**SERVICE
BULLETIN**

MANDATORY BULLETIN Z 242L/29a, Z 143L/16a

3. SUBJECT: Occurrence of the checking block L 143.8521 damage in operation.
4. CORRECTION:
 - 4.1 Repair of the block - removal of the cooler eloxal coating and/or replacement of defective transistors in the checking block, if necessary.

Fig.: Checking block L 143.8521

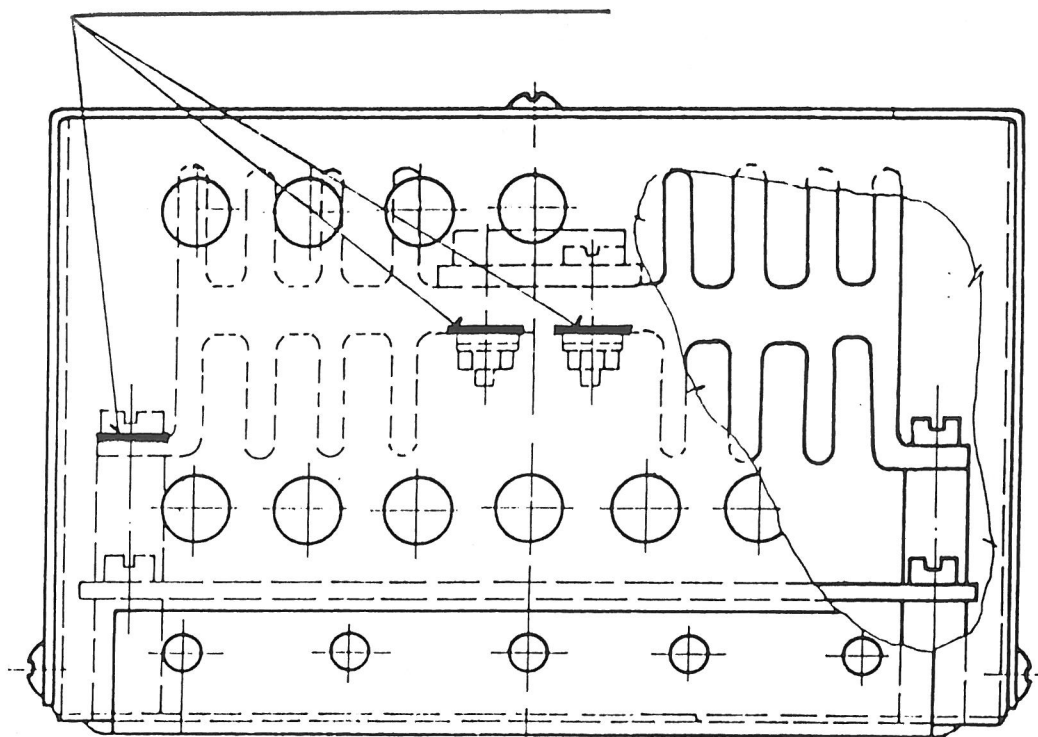
- 9.3 Removal of the failure cause:
Remove the eloxal coat layer of the cooler under attachment nuts of all three KD 503 transistors (or their equivalents) and under the screw of the supply voltage lead to the cooler. After cleaning off and tightening, re-paint these joints with the protective lacquer.

REMOVE THE ELOXAL COAT LAYER
